**Proposed EV Mobility City with Ancillary Staff Quarters and
Talent Accommodation at Various Lots in D.D. 51 and
Adjoining Government Land, Fanling
(Application No. Y/FSS/20)**

- Further Information No. 4 -

**S.12A Amendment of Plan Application
Proposed EV Mobility City with Ancillary Staff Quarters
and Talent Accommodation at Various Lots in D.D. 51 and
Adjoining Government Land, Fanling**

(Application No. Y/FSS/20)

Alternative Development Scheme

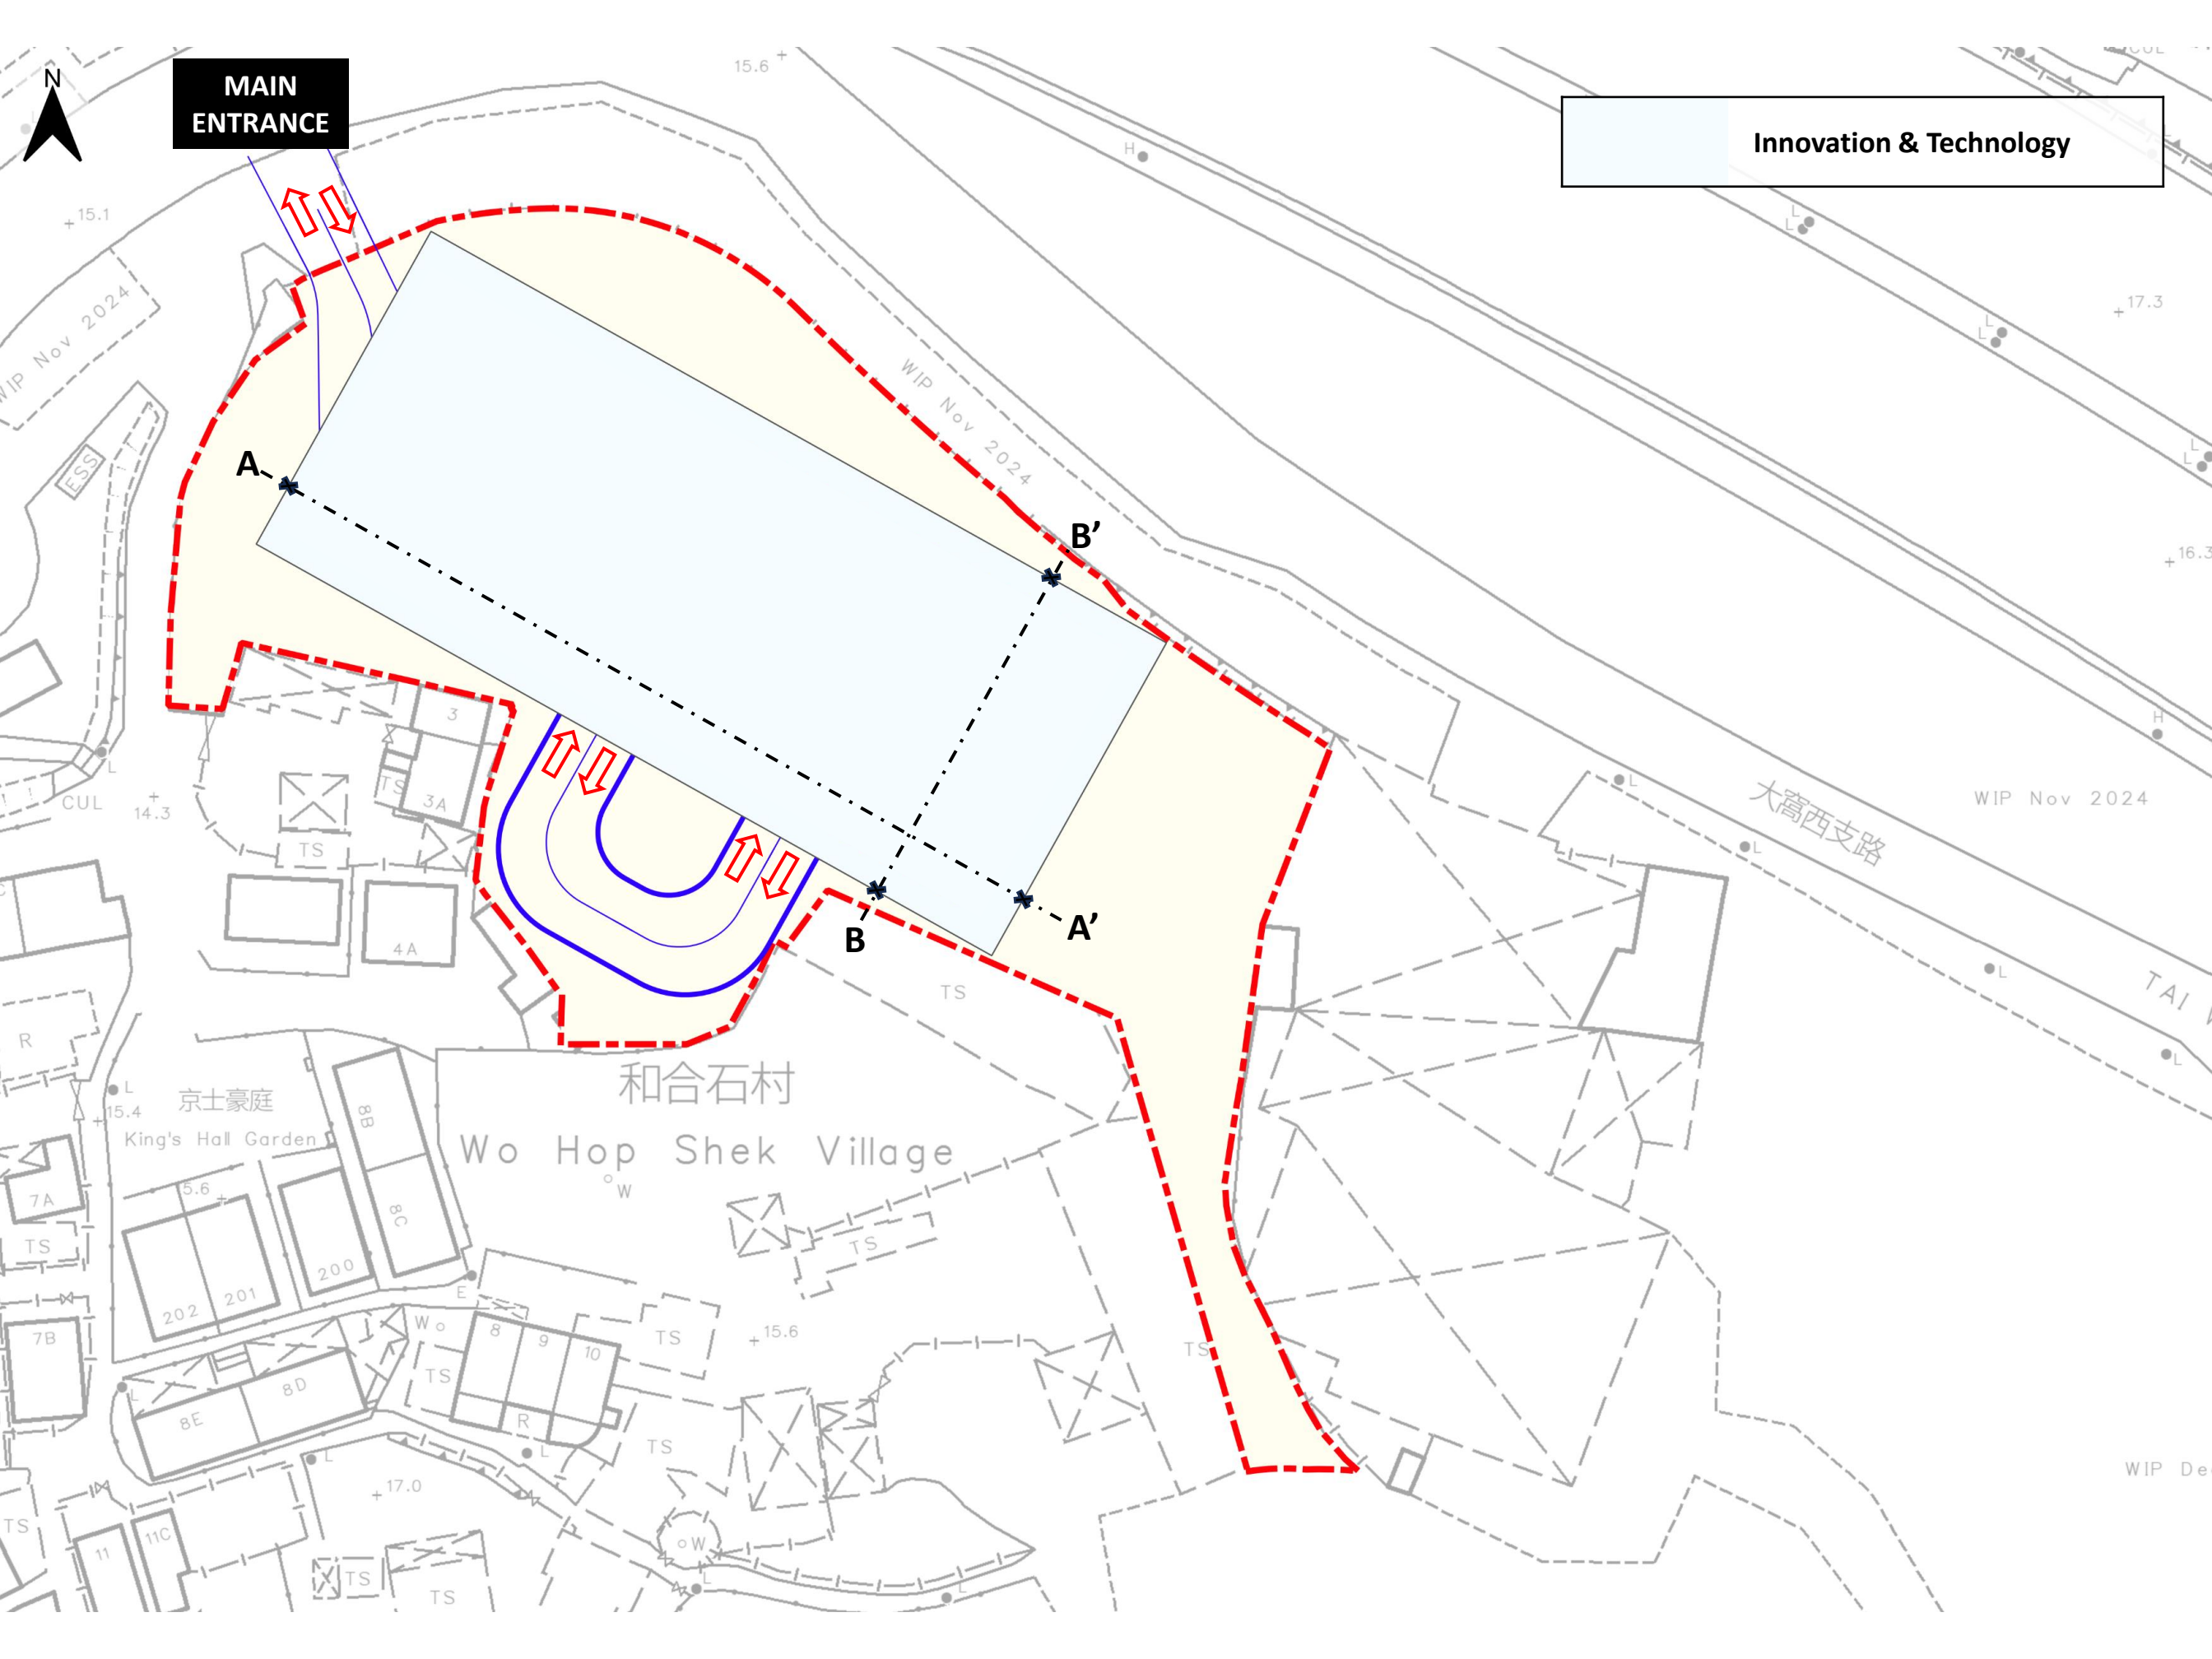
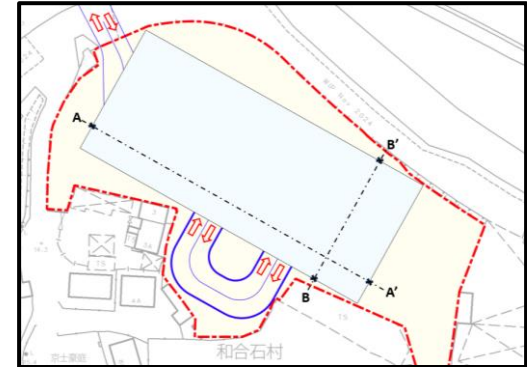
Comments	Responses
Comments from Fanling, Sheung Shui & Yuen Long East District Planning Office, Planning Department (Contact Person: Ms. Andrea YAN; Tel: 3168 4049)	
<p>1. In support of the applicant’s proposal for a non-domestic PR of 5 as stipulated in the proposed Notes for the “OU(I&T)” zone, please provide indicative drawings for a proposed development solely for non-domestic use and illustrate whether such proposal will cause any adverse impact;</p>	<p>An alternative development scheme, illustrating the scenario of a solely non-domestic development, has been prepared at Annex A. As indicated in the respective technical assessments and the elaborations below, from technical perspectives, no adverse impact is anticipated for the scenario of alternative development scheme. Details as follows:</p> <p>Environmental</p> <p><u>Noise</u></p> <p>Same as the Current Scheme, the Proposed Development, which mainly focuses on clean energy and EV, as well as R&D works, is non-polluting in nature. Noise generating activities, if any, would be located within the enclosed area of the building and positioned away from any noise sensitive receivers (especially the future public housing development at nearby Fanling Area 48) as far as possible. Also, there will be no noisy operations during night-time period (i.e. 23:00 to 07:00). Moreover, the Proposed Development (including work bays and pre-delivery inspection spaces) is not expected to induce any significant noise impact, as the activities involved are only limited to sales, repair/ maintenance, testing and laboratory studies of EVs. In other words, there will be no noise-intensive processes, such as assembly or manufacturing. Regarding the car ramp, appropriate mitigation measures and building design (including but not limited to an enclosed vehicular ramp) will be considered during the next stage of detailed design if found necessary by the relevant Government departments. Therefore, it is anticipated that no adverse fixed noise impact will be generated by the alternative scheme on the surrounding NSRs.</p>

Comments	Responses
	<p><u><i>Air Quality</i></u> Same as the Current Scheme, there is no industrial chimney induced from the alternative scheme and there will not be any industrial activities which involve certain polluting industrial processes classified as “specified processes” under Air Pollution Control Ordinance, Cap. 311. No adverse air quality impact on surrounding air sensitive uses is anticipated during its operation.</p> <p>Drainage & Sewerage</p> <p><u><i>Drainage</i></u> The amount of surface runoff generated from the alternative scheme and flow regime will remain unchanged. Therefore, it is anticipated that there is no adverse impact on the existing drainage pipe receiving runoff from the site.</p> <p><u><i>Sewerage</i></u> The estimated discharge flow rate of the alternative scheme (approx. 287.6 m³/day) will be slightly lower than that of the current scheme (approx. 297.7 m³/day), representing a slight reduction of approx. 10.1 m³ per day. In this regard, the conclusions of the SIA are deemed applicable to the alternative scheme, and thus no adverse impact on the existing sewerage system will be induced.</p> <p>Traffic</p> <p><u><i>j) Difference in Traffic Generation / Attraction</i></u> Traffic generated by the alternative scheme is estimated using the same methodology detailed in the TIA dated 17th December 2025 (hereinafter “the TIA”), and is summarized in Table T1.</p>

Comments	Responses
	<p>which are both negligible compared to the traffic flows in the surrounding road network.</p> <p>The difference in traffic generation / attraction between the Current Scheme and the Alternative Scheme is opined minimal; thus, the analyzed junctions and road links presented in the TIA are expected to continue to operate with similar operation condition comparing with the Current Scheme.</p> <p><i>ii) Provision of Internal Transport Facilities</i> Internal transport facilities provided for the Proposed EV Mobility City will continue to comply with the recommendation under HKPSG. Should the Alternative Scheme be adopted, internal transport facilities will also be provided based on the development parameters and in accordance to the recommendation of the HKPSG.</p> <p><i>iii) Conclusion</i> Both Current Scheme and Alternative Scheme are acceptable from traffic engineering point of view.</p> <p>Visual As compared to the current scheme (a composite development), the alternative scheme features a significantly lower building height at about +72.25mPD. In this regard, it is envisaged that the alternative scheme will bring even a lesser visual impact and that no significant visual impact will be resulted.</p>
